Product Change Notice (PCN)

Subject: Tape & reel packing change for M16C LQFP 48pin products

Publication Date: 4/22/2024

After Reel diameter: $\phi 330\text{mm}$

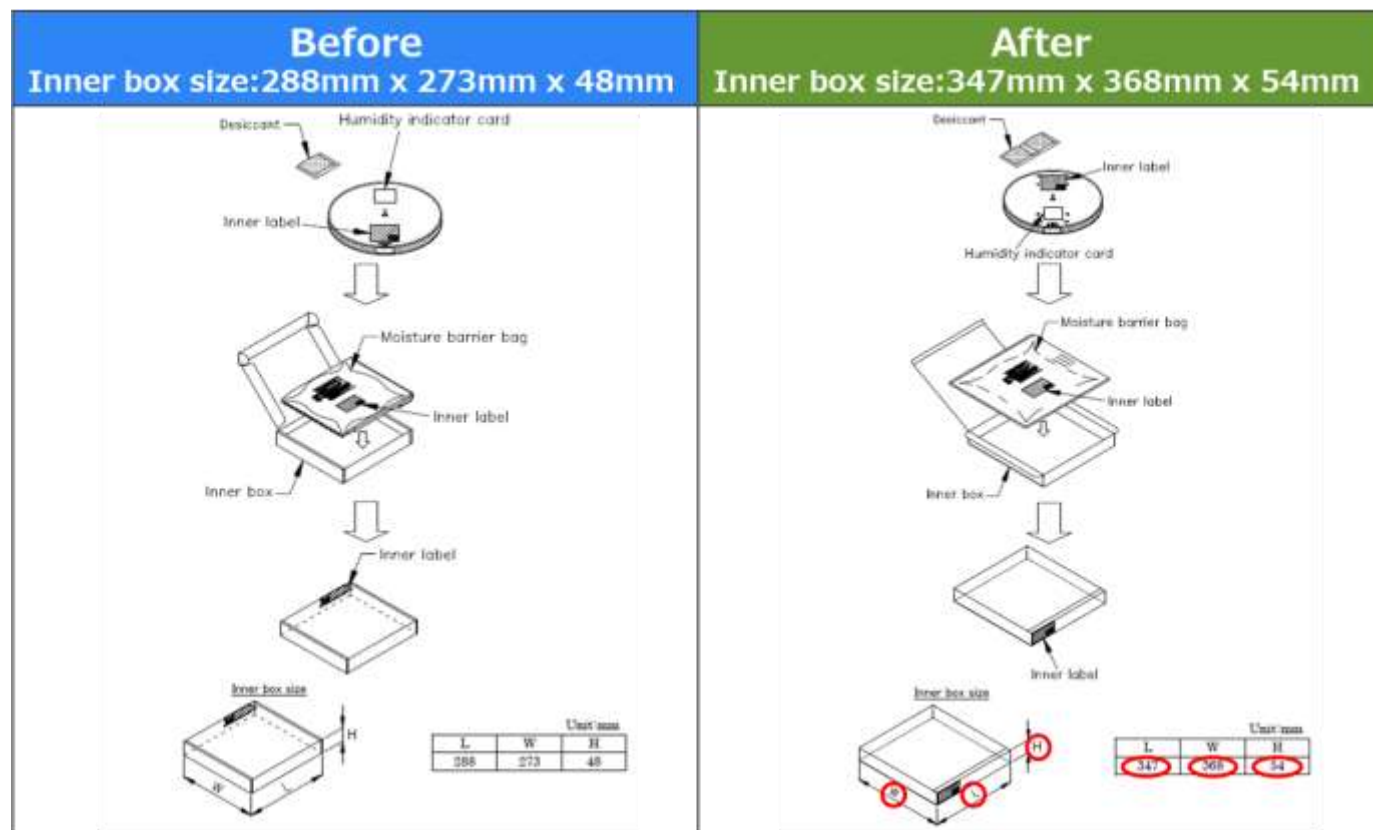
Comparison of tape & reel dimension: 7x7mm LQFP Tape & Reel packing

Tape Code	E1612Q07RA
W	16.0
P1	12.0
AD	9.5
BD	9.5
KB	1.40
F	7.50
D1	1.5
A	330
N	100
W1	17.4
W2	21.4
Maximum storage Pos./IC/ Reel	1000
Material	Carbon PS
Surface resistance	Less than $1 \times 10^{11} \Omega/\square$
